Subject:- An estimate for repairing the principal structures at the sevam pagodas.

12th April 1881, No. 967 W.

No. 41-A From Captain A. AWDRY, R.E., Superintendent of Works, Buckingham Canal, to the Chief Engineer, Public Works Department, dated Madras, 27th November 1880, No. 2,259.

No. 41-B From R. SEWELL, Esq., Archaeological Reporter to Government, and R. F. CHISHOLM, Esq., Consulting Architect to Government, to the Chief Engineer and Secretary to Government, Public Works Department, dated Madras, 22nd February 1881, No. 644.

No. 15, or *Krishna Mundapam*.—In this there are very bad leaks down the back over the sculptures, the roof is stone slabs with earth over them, and where it abuts against the rock behind there is no proper drain.

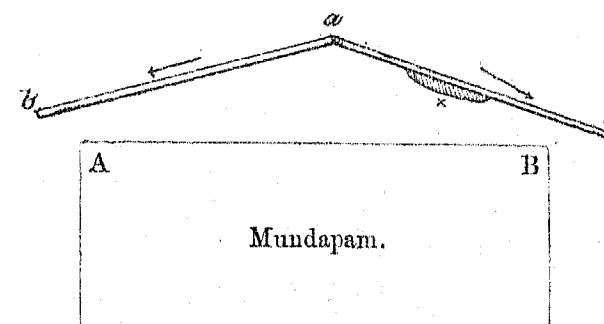
Small drains *a, b, c* should be made sloping downwards the face *A B* of the Mundapam being out out of the rock and the roof being about the level of the top of the rock which slopes upwards to *a*.

There should be a small wall built on the lower side, a notch being cut as a footing. The work will be—

Stone slab on edge fixed in a groove to be cut in the rock.

The end walls of the Mundapam require to be built up to prevent further damage.
